NUMBER: 07-001-10

Belt Chirp When Steering Wheel Is At Full Lock With Engine RPM At Idle

This bulletin involves inspecting the belt tensioner and if necessary replacing it.

Fig. 1 DRIVE BELT TENSIONER

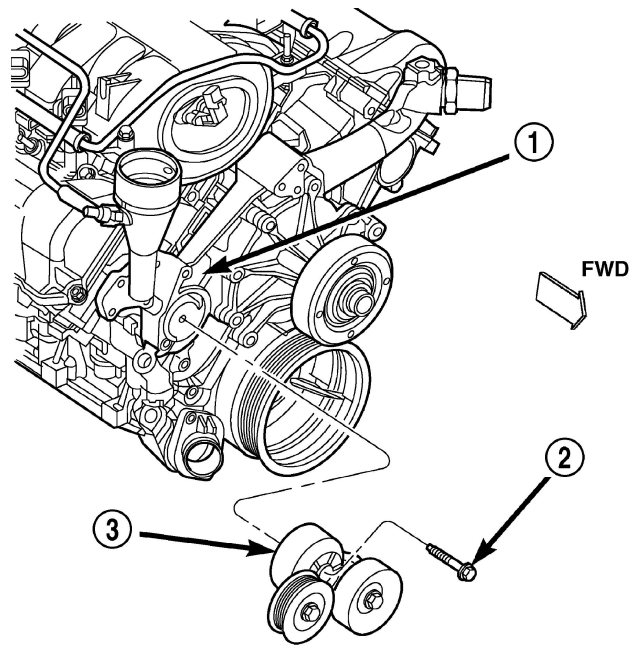
1. Open hood.
2. Read part number on the top front face of the belt tensioner (Fig. 1).

- 3. Is the part number 53030958AE?
 - a. Yes >>> Further diagnosis in required.
 - b. No >>> Replace drive belt tensioner (p/n 53030958AE)

- 1 - TIMING CHAIN COVER
- 2 - BOLT TORQUE TO 41 N·m (30 FT LBS)
- 3 - DRIVE BELT TENSIONER
